Geological objections to
Surrey County Council planning application no. 2018/0152
by
UK Oil & Gas for hydrocarbon developments at Horse Hill

David Smythe

21 June 2019

Fig. 2.1

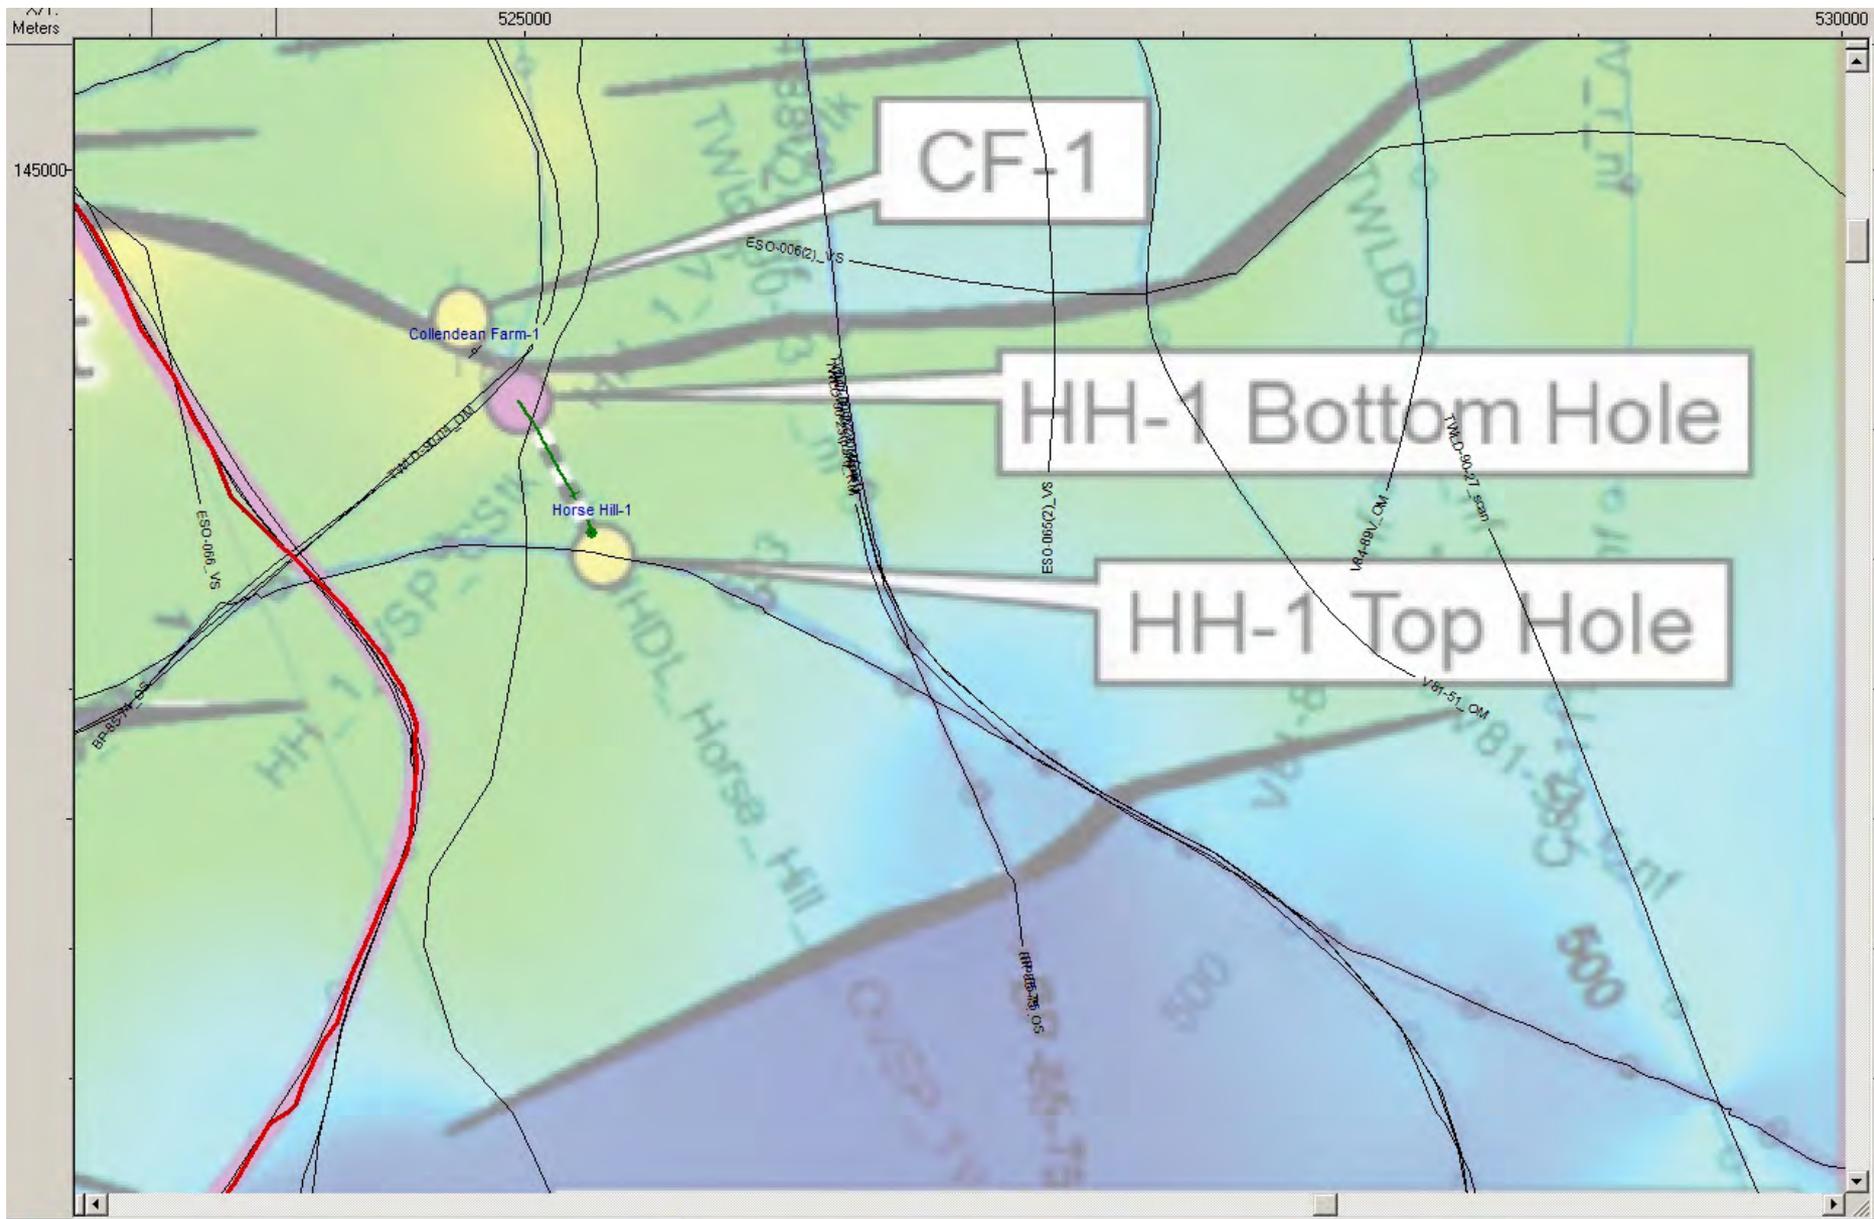
Figure 2.1 shows a detail of the Top Great Oolite depth structure map, submitted in application by UKOG in May 2019. The digital seismic overlay (black lines) matches the underlying colour image well, suggesting an error of under 10 m in the registration of the image within the Kingdom v8.8. seismic interpretation package. However, the well locations are in error. Figure

Detail of the Top Great Oolite depth structure map, submitted in application by UKOG in May 2019. Note the location errors of CF-1 and HH-1.

Fig. 2.2

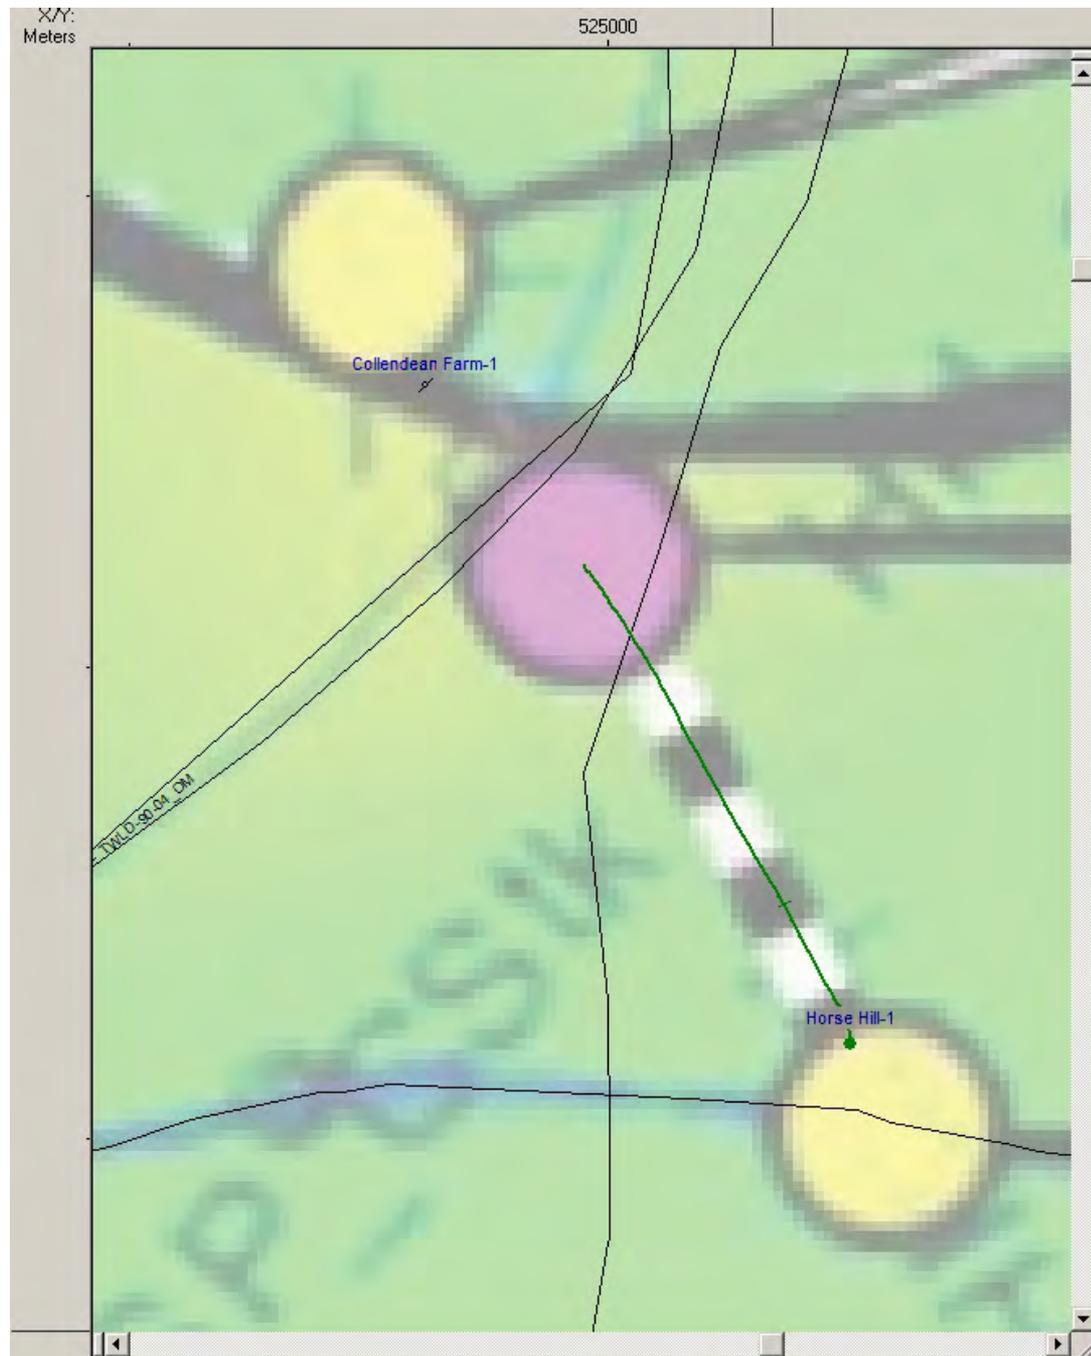
2.2 shows a close-up of the map. Collendean Farm-1 (yellow disc) is about 130 m NW of its correct location shown in small print. A tabulation of the grid coordinates for this well and for Horse Hill-1 (HH-1) is given in Figure 2.3. The erroneous UKOG location for CF-1 is shown in blue. The correct location, given by Esso in its composite well log header, is shown in Figure 2.4 (BNG = British National Grid). It is in a large field, which I have personally viewed from the road to the east. In contrast, all the UKOG and earlier Magellan maps place the well in a stream in the vale (or dean, hence the name Collendean) to the NW. This is a highly unlikely location, given that the stream was there in the 1960s when the well was drilled (Fig. 2.4 inset) and, indeed, back at for least 100 years, as shown by archived OS maps.

In Figure 2.2, the toe of HH-1 (crimson disc) is in the correct location.

Close-up view of the map shown in Fig. 2.1. Collendean Farm-1 (yellow disc) is about 130 m NW of its correct location shown in small print.

Fig. 2.3

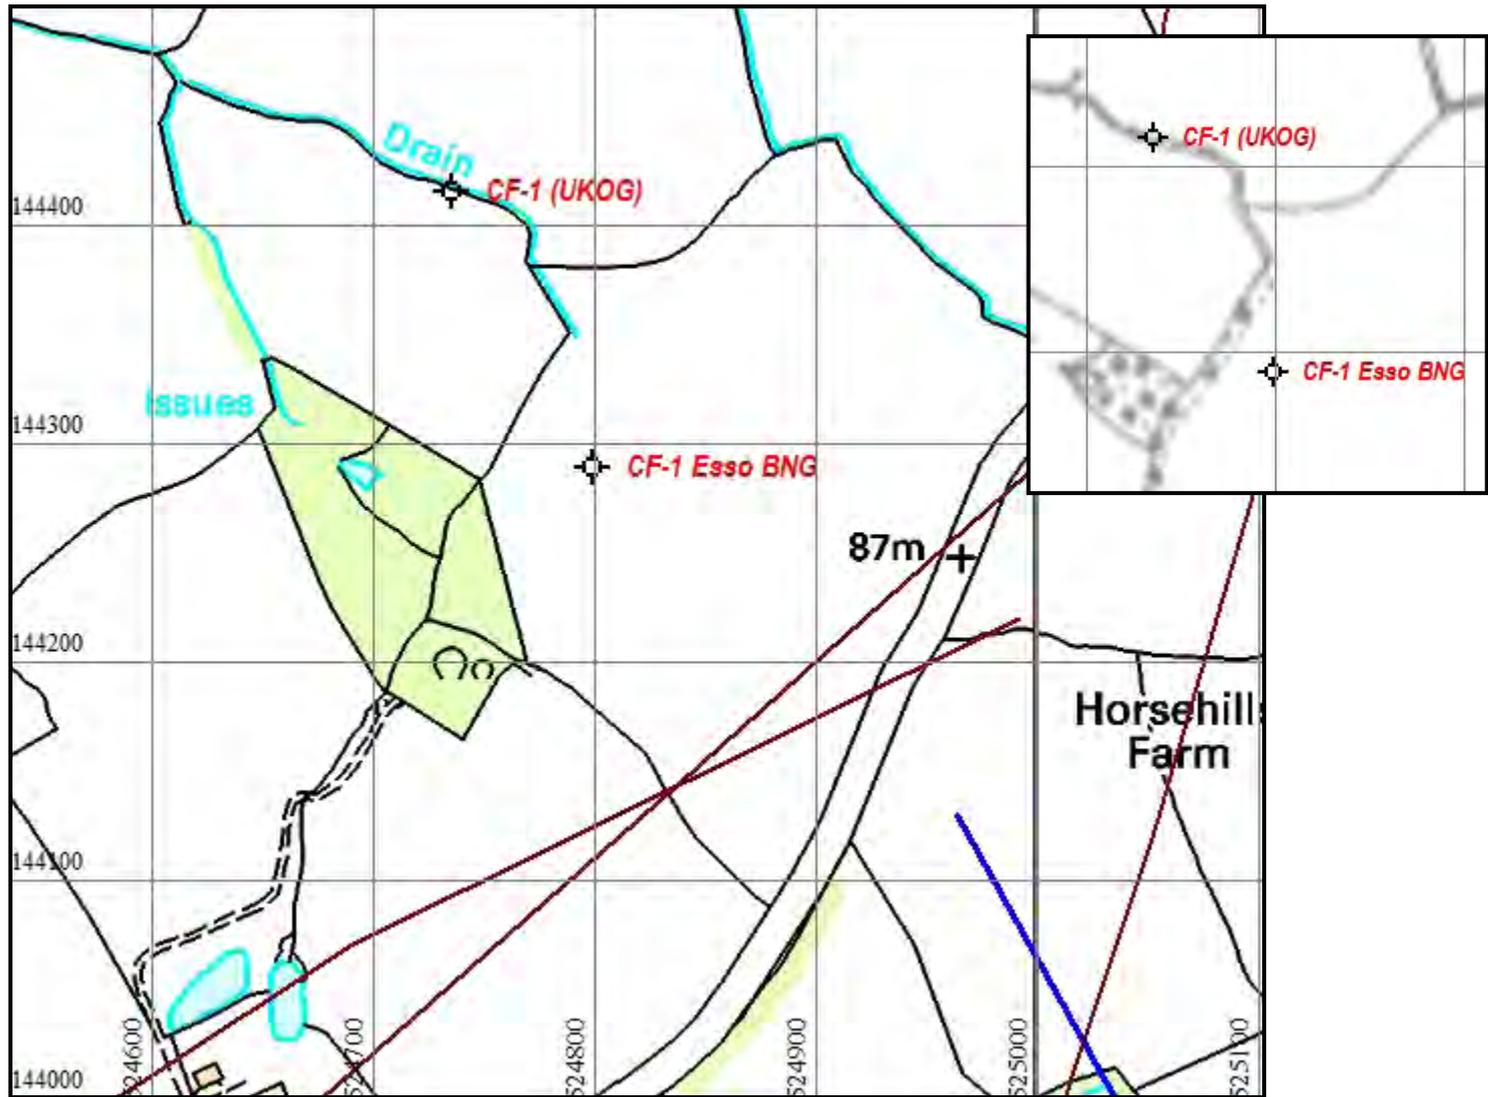
Well	East	North	Source of coordinates	Notes
HH-1	525254	143600	DECC	
	525307	143514	UKOG map June 2019	
CF-1	524811	144300	DECC	
	524800	144290	Esso composite log header	10 m precision
	524752	144418	UKOG map June 2019	
Distances		m		
CF-1 to HH-1		828	DECC	measured
		1064	UKOG map June 2019	measured
CF-1 to HH-1		828.4	DECC	calculated
		1060.8	UKOG map June 2019	calculated

Tabulation of the grid coordinates for Collendean Farm-1 (CF-1) and for Horse Hill-1 (HH-1) The UKOG plotted distance between the wellheads is about 70 m greater than the true distance.

Fig. 2.4

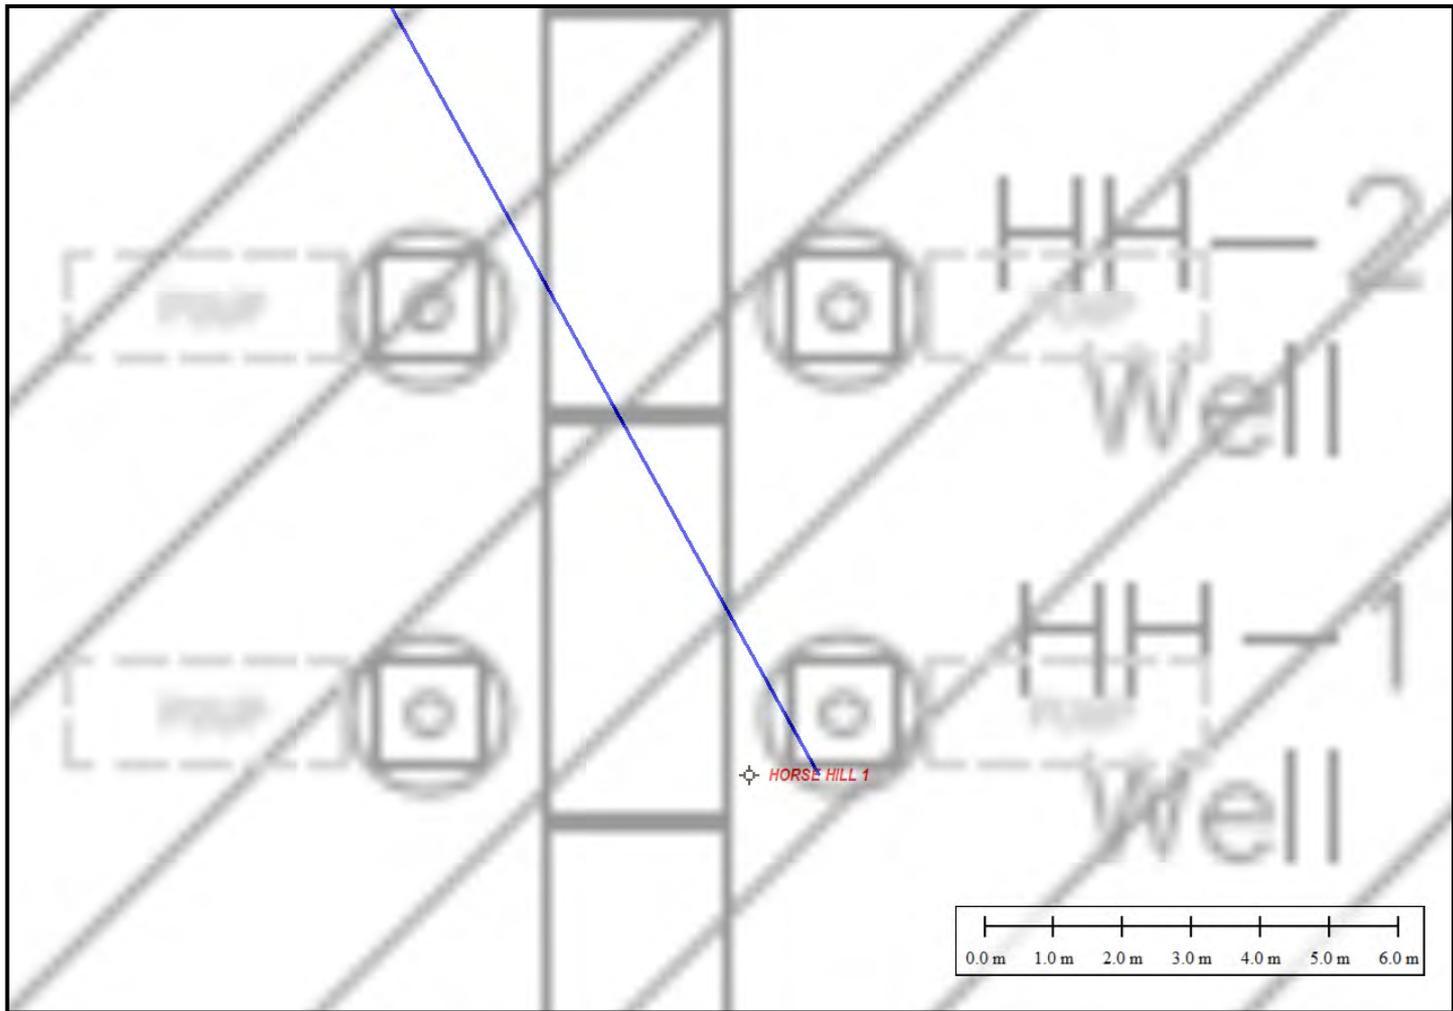
Erroneous location of CF-1 by UKOG in a stream. The inset shows the OS map from the 1960s, demonstrating that the stream existed then. The correct location, defined by the operator Esso in 1964, is shown, specified in British National Grid (BNG) coordinates.

Fig. 3.2

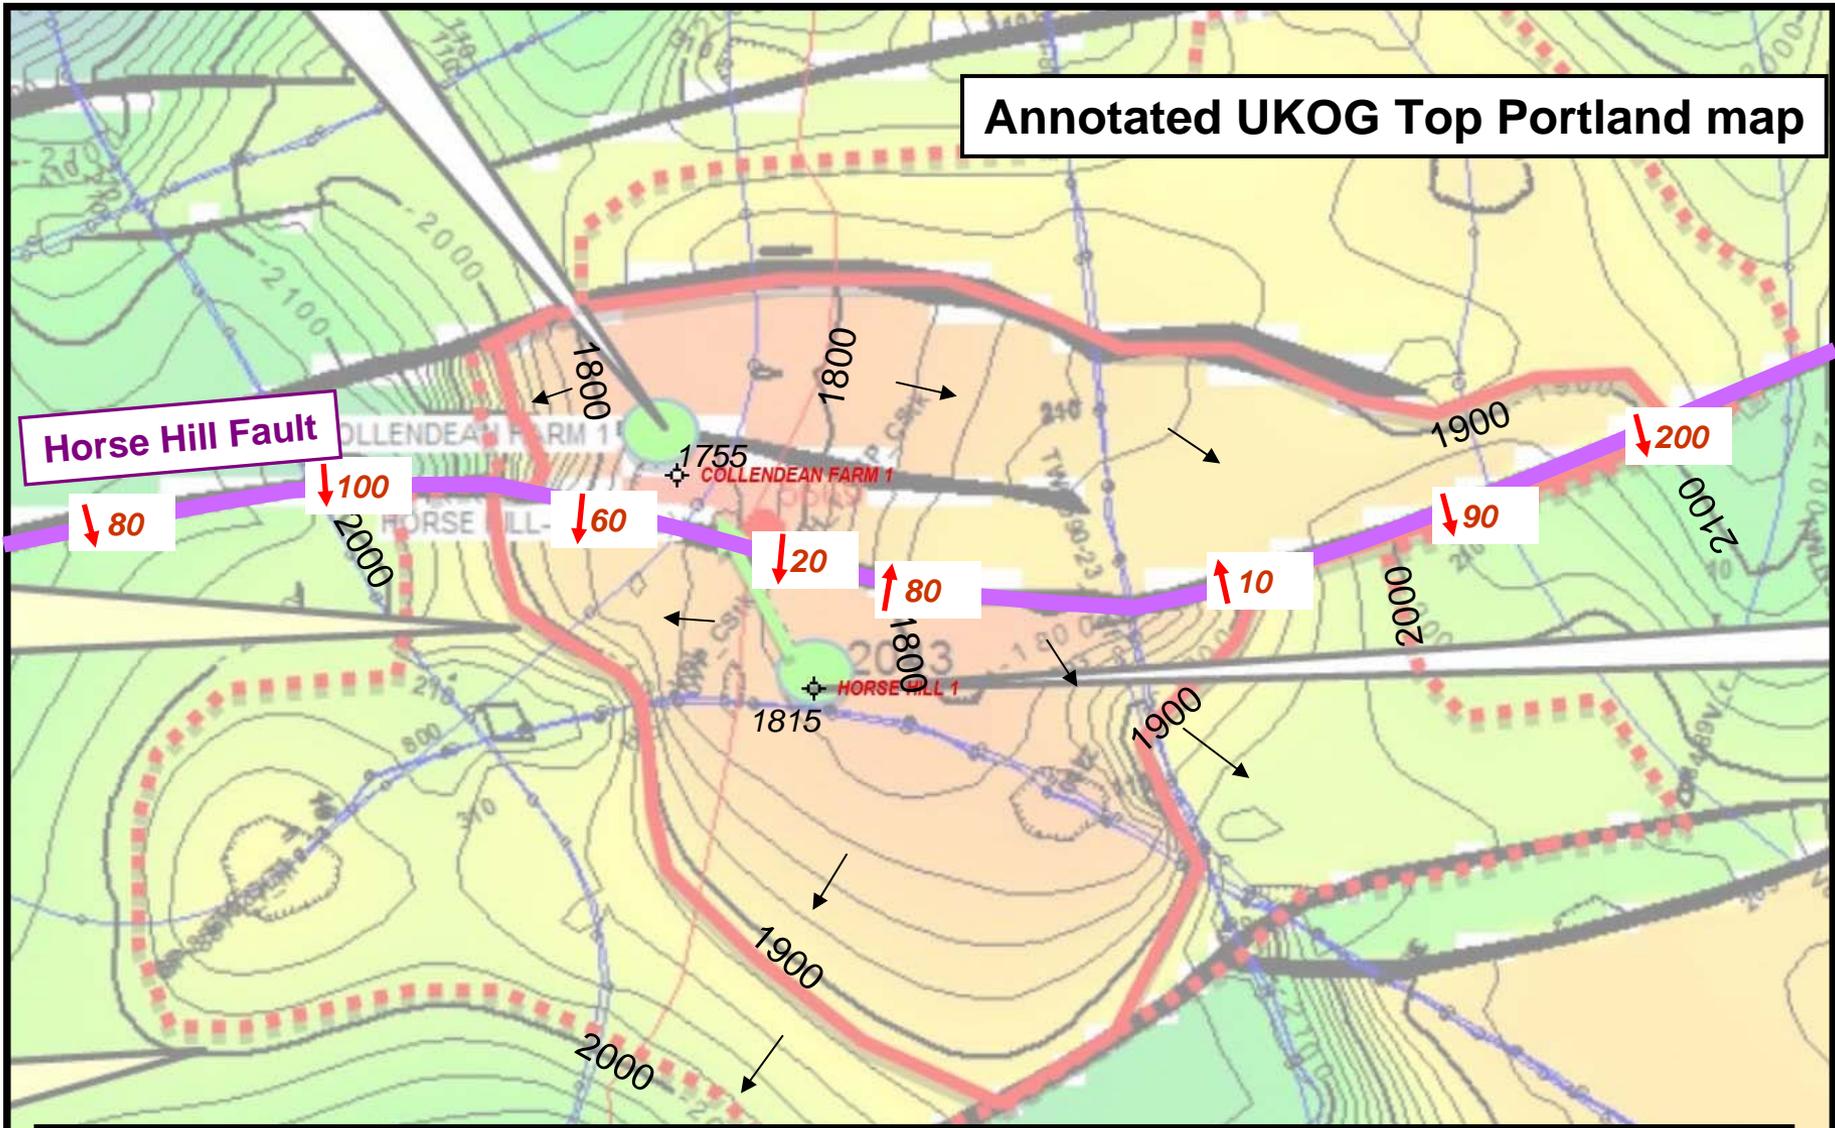
Figure 3.2 shows the image of UKOG's Top Portland Prospect (February 2015) as an underlay to the database. HH-1 and the deviated well track are in approximately the correct location; CF-1 (green disc) is in the wrong location (cf. Fig. 2.4). The dotted orange line in the top left-hand

corner is the edge of the structure, as outlined by the orange hatching in Figure 3.1. Note that the offsets at the faults show that the downthrows are to the south.

Fig. 3.3

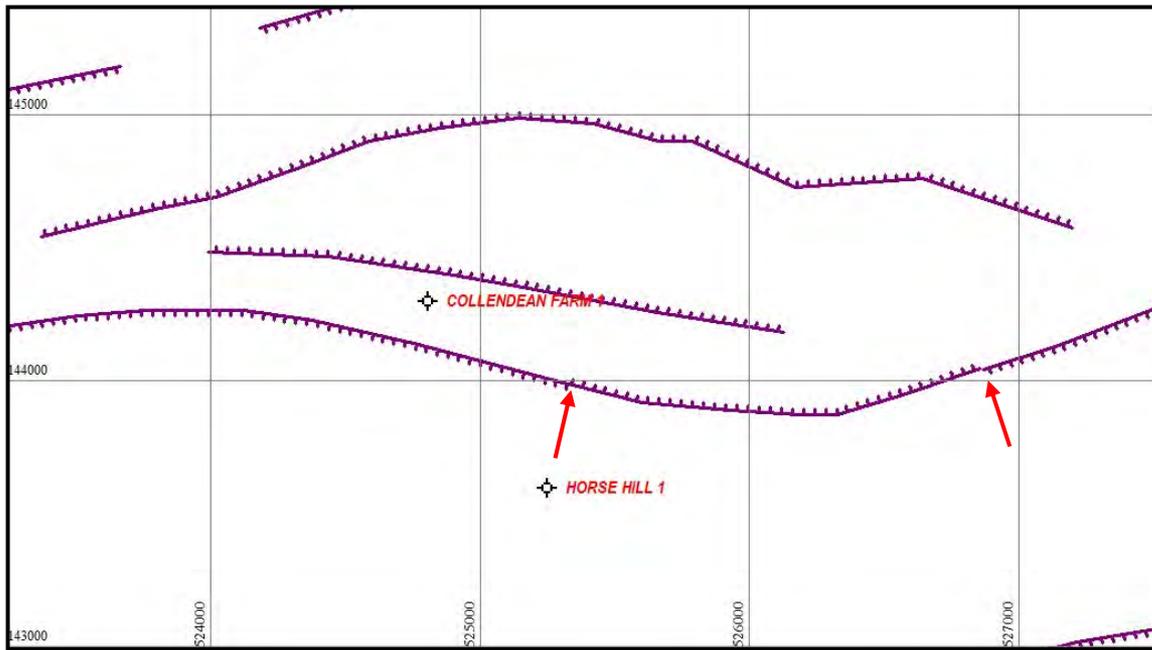
Figure 3.3 shows the whole Top Portland prospect map. The 'Horse Hill Fault' is now marked with a thick lilac line. Black arrows show local dips. The red arrows along the fault show the throw across the fault in feet, read off from the contours on either side. The downthrow is predominantly southwards-facing, but locally NE of HH-1 the throw is down to the north. Such a sense of changing throw direction is highly unlikely in the Weald, although it is technically possible in basins with a pronounced strike-slip fault geometry. There is no evidence for such geometry in the Weald. Here it is an artefact of poor seismic interpretation.

Labelling is in feet below sea level. The dashed red line corresponds to the maximum closure. Local dip directions are shown by black arrows, and the local throw (the vertical displacement) along the Collendeen Farm Fault is shown by the red arrows pointing to the downthrown side. Note the local change of sense of throw, NE of HH-1. The depth at the two wells is marked. Note that the Top Portland at HH-1 is deeper than at CF-1 (drilled by Esso in 1964) by 60 ft (18 m).
